Re: 14th & Ursula Mixed-Use (DA-1279-53 / 2022-4021-00) / 1st Review Comment Response

Thank you for taking the time to review our initial submission for the 14th & Ursula Mixed-Use at Fitzsimons Village along with City staff and providing valuable feedback, which was received on July 15, 2022. Comment responses have been addressed on the following pages.

PLANNING DEPARTMENT COMMENTS

SHEET TITLE:
LANDSCAPE
ENLARGEMENT

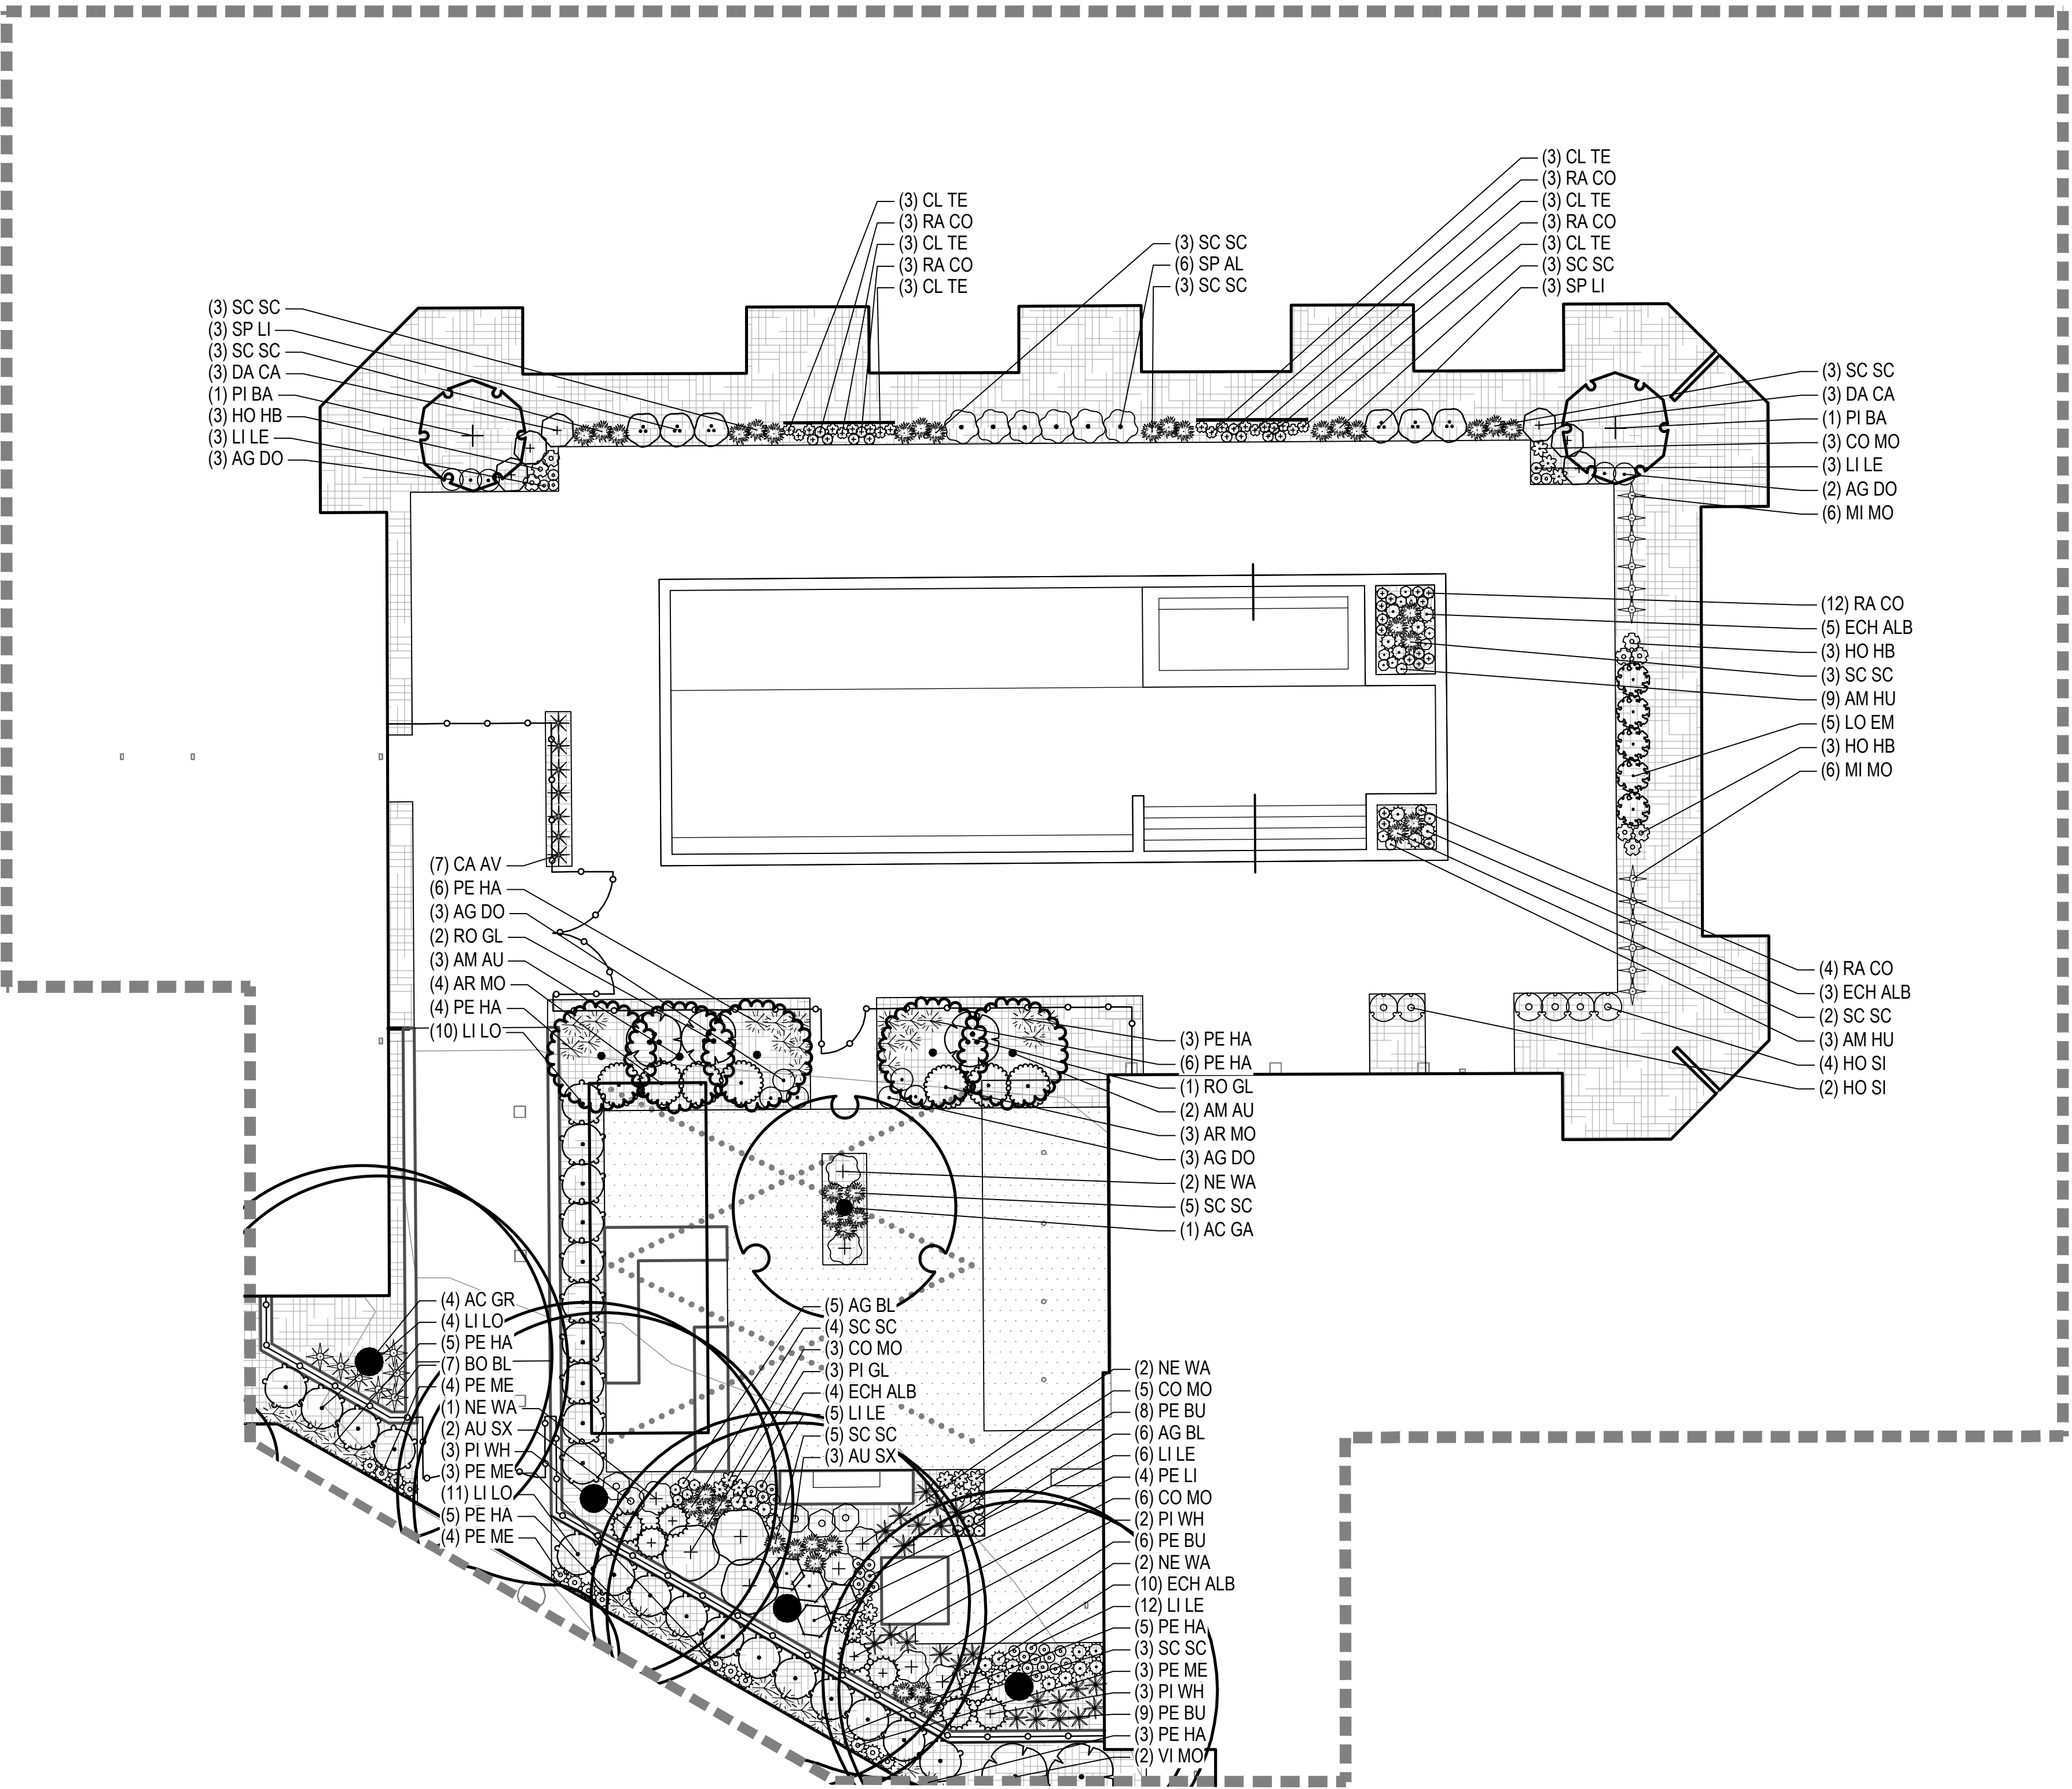
Please ensure that all standard concrete has 5-foot by 5-foot score lines and there should be light terra cotta concrete pavers placed between the tree openings per the Fitzsimons Boundary Area Public Realm Design Standards. Label and show this on the site plan.

Streetscape design includes 5x5 concrete scoring and terra cotta colored concrete similar to existing developments within Fitzsimons Village.

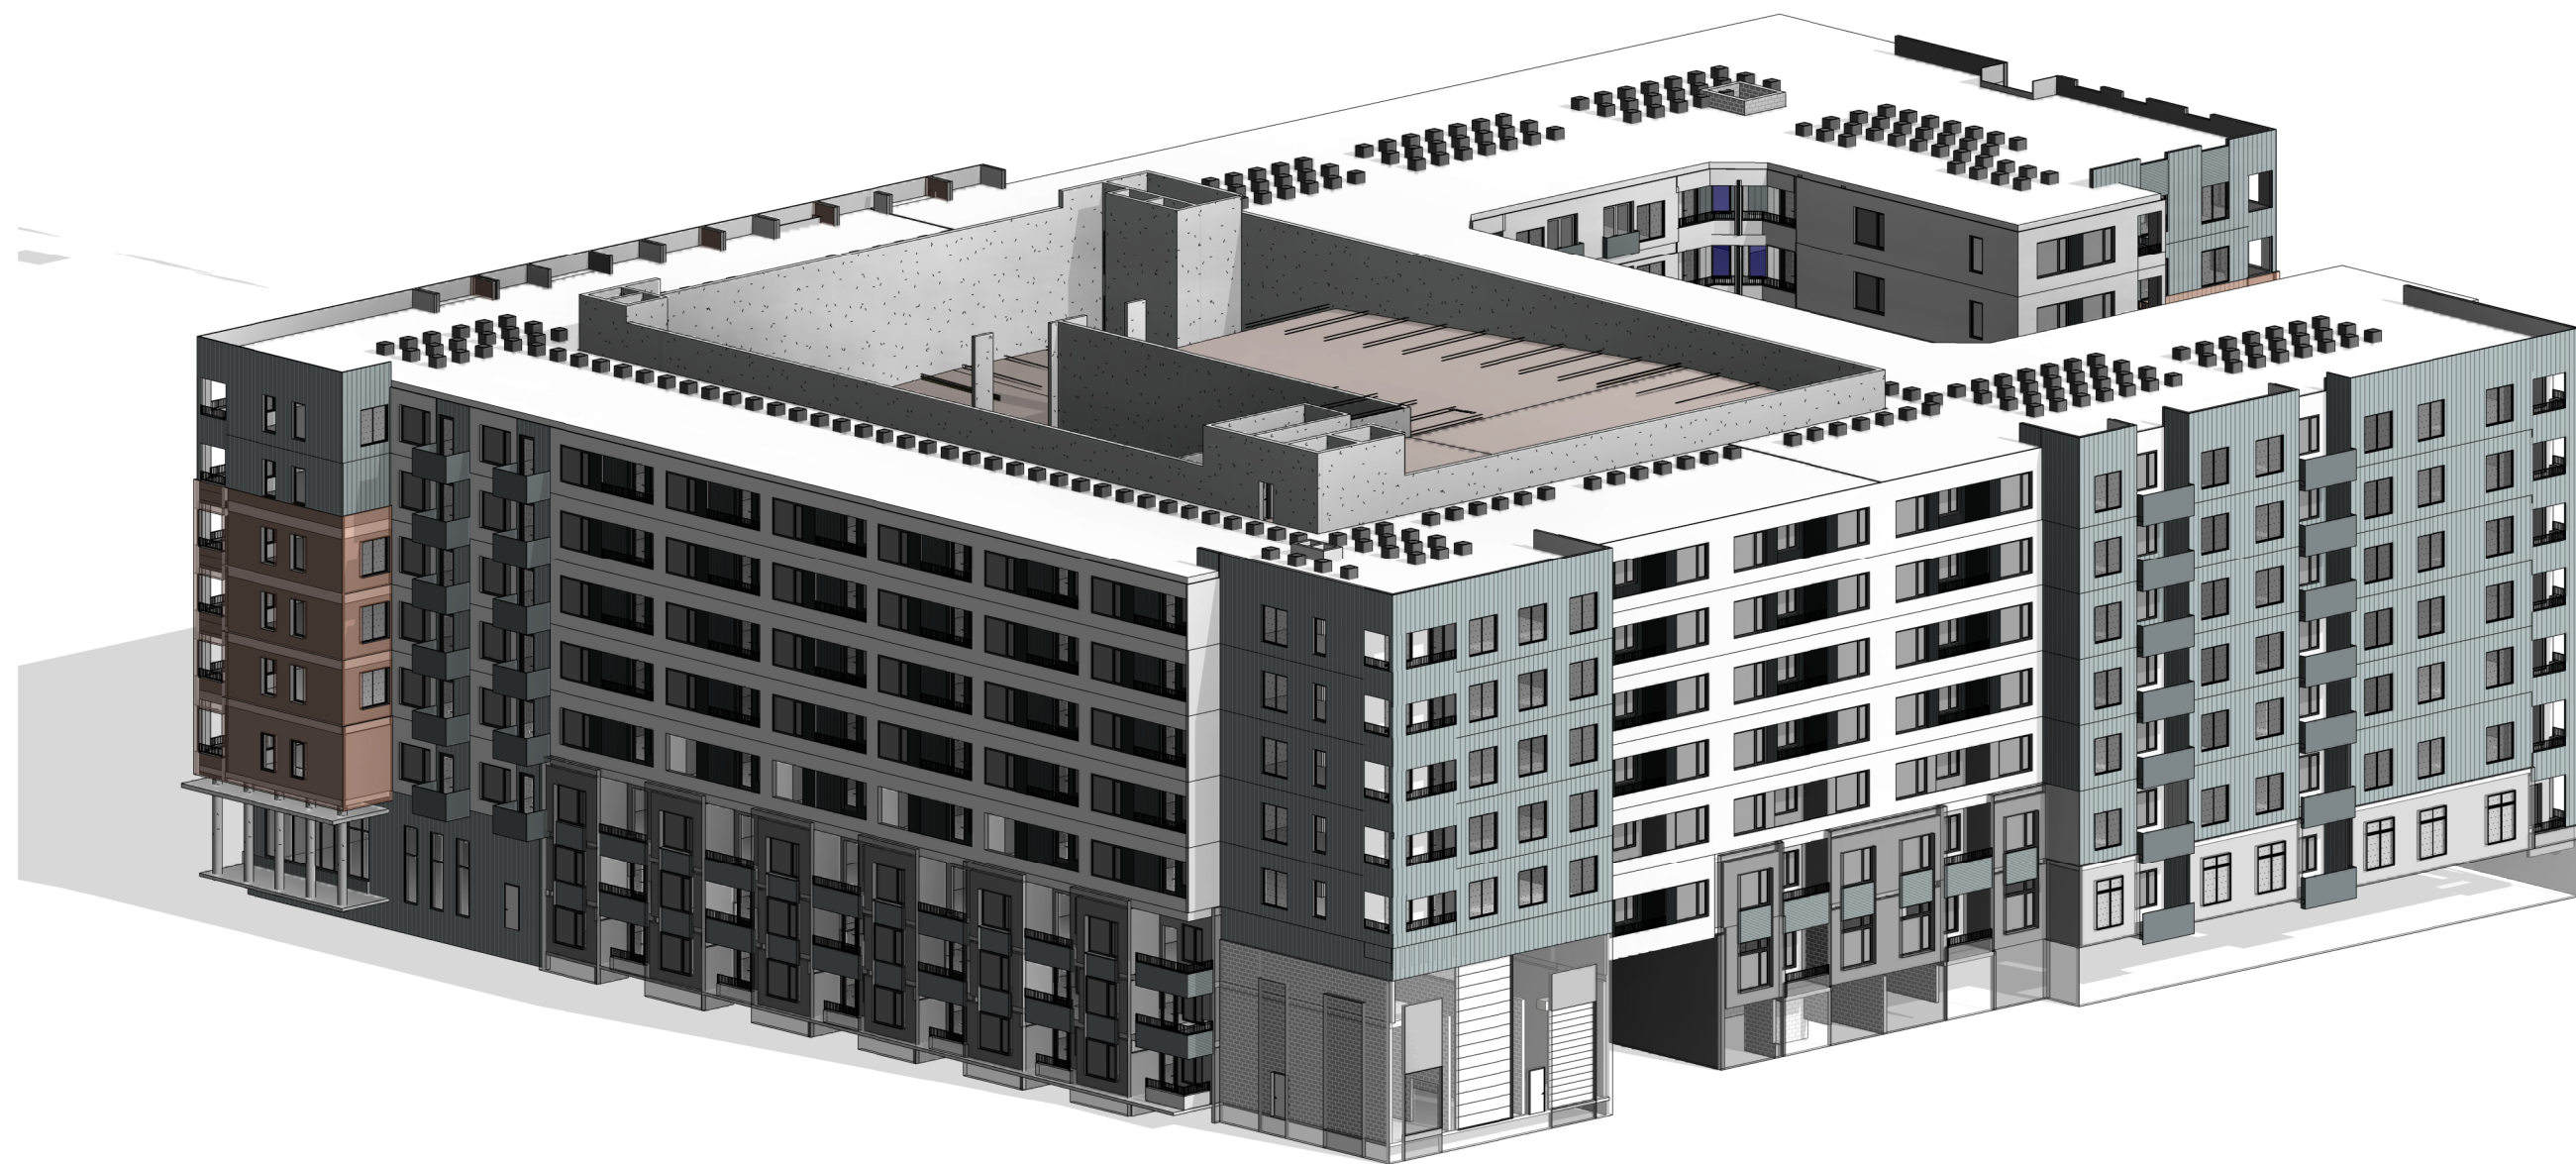
Delete all signage.
Show a dashed box only where signage is proposed.

Noted, dashed box added
